Product Change Notice (PCN)

Subject: Bond wire material change for RL78/F13, F14 Series 32pin QFN package products

Publication Date: 3/21/2025

■Part number specification

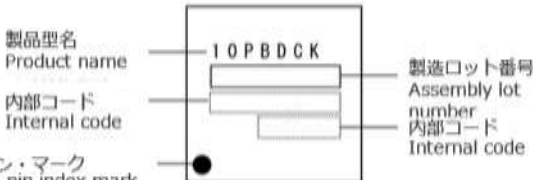
The code "C" representing Cu wire is inserted in part number of Cu wire products for distinguishing from Au wire products wire products and Au wire products have different suffixes. See below for table.

Body	Suffix(Packing type)		
			Tray (Full carton)	Tray	T/R
Current	Au wire	R5F1xxxx	G5	U5	W5
Alternative	Cu wire	R5F1xxxxC	15	35	55
Points to changes		9桁目に"C"追加 "C" is added to the 9th digit.	末尾から2桁目が変更(末尾"Q"の時は末尾から3桁目が変更) The second digit from the end of the Suffix change. (If "Q" at the end of Suffix, the third digit from the end change.)

Ex) Cu wire: R5F10PBDCKNA#15

Au wire: R5F10PBDKNA#G5

■Package Outline (1/2)

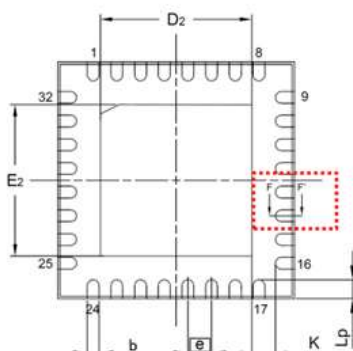
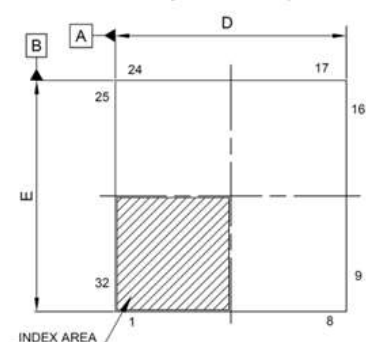
HWQFN with Half-cut Wettable flank

Alternate Cu wire

■Package Outline (2/2)

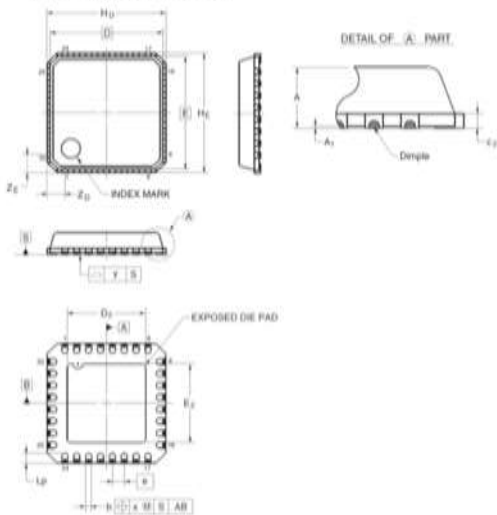
HVQFN with Dimple Wettable flank
Current Au wire

■ Packing change (1/2)

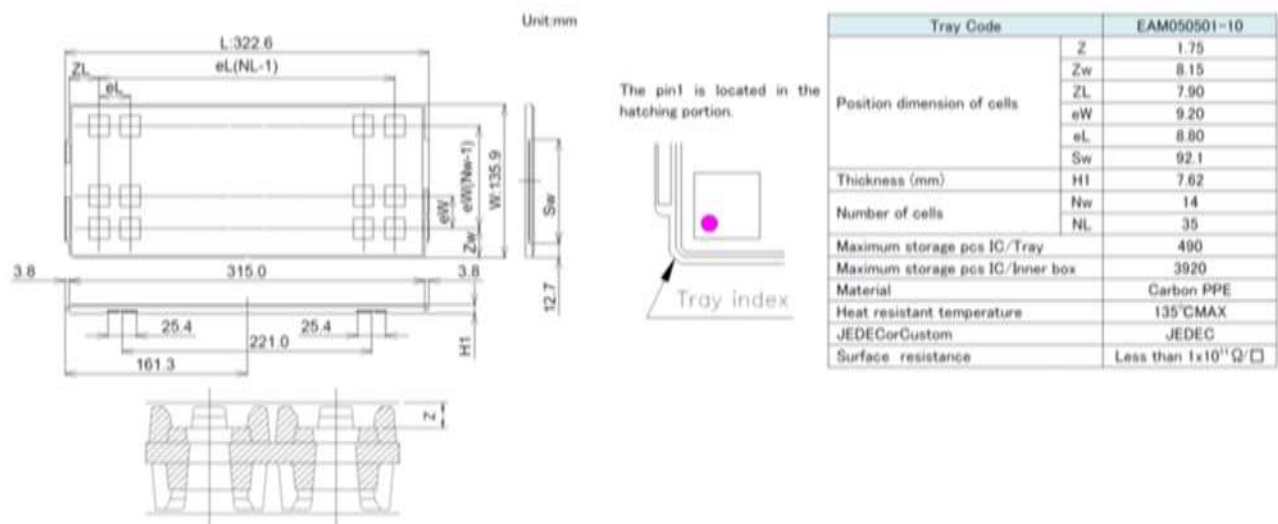
The tray will be changed as follows.

Alternate Cu wire

■ Packing change (2/2)

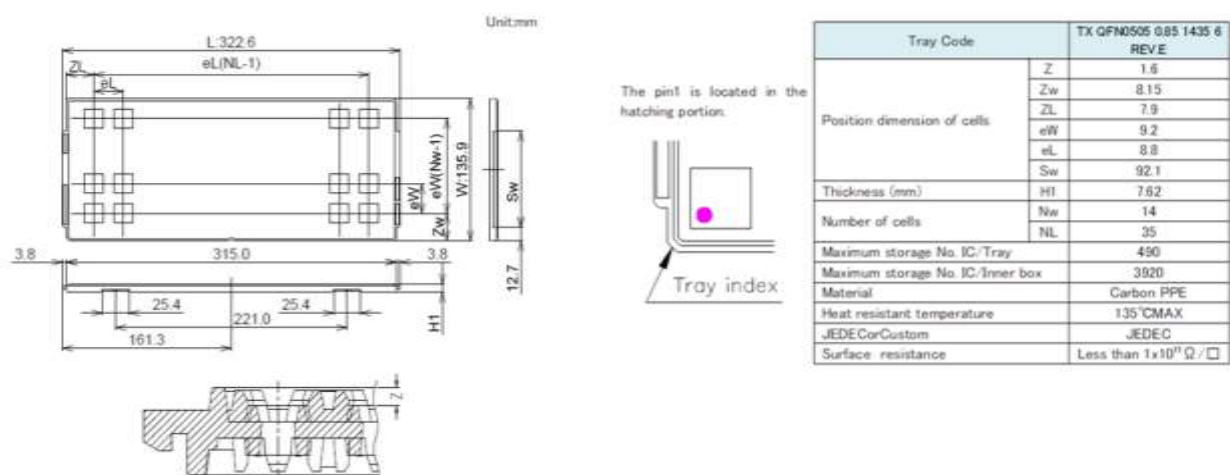
Tray Outline Drawing (Dimension comparison)

Alternate Cu wire RSKL RL78/F13. F14			Current Au wire RSKL RL78/F13. F14		
Tray Code		EAM050501-10	Tray Code		TX QFN0505 0.85 1435 6 REV.E
Position dimension of cells	Z	1.75	Position dimension of cells	Z	1.6
	Zw	8.15		Zw	8.15
	ZL	7.90		ZL	7.9
	eW	9.20		eW	9.2
	eL	8.80		eL	8.8
	Sw	92.1		Sw	92.1
Thickness (mm)	H1	7.62	Thickness (mm)	H1	7.62
Number of cells	Nw	14	Number of cells	Nw	14
	NL	35		NL	35
Maximum storage pcs IC/Tray		490	Maximum storage No. IC/Tray		490
Maximum storage pcs IC/Inner box		3920	Maximum storage No. IC/Inner box		3920
Material		Carbon PPE	Material		Carbon PPE
Heat resistant temperature		135°C MAX	Heat resistant temperature		135°C MAX
JEDEC or Custom		JEDEC	JEDEC or Custom		JEDEC
Surface resistance		Less than $1 \times 10^{11} \Omega / \square$	Surface resistance		Less than $1 \times 10^{11} \Omega / \square$
EAM050501-10			TX QFN0505 0.85 1435 6 REV.E
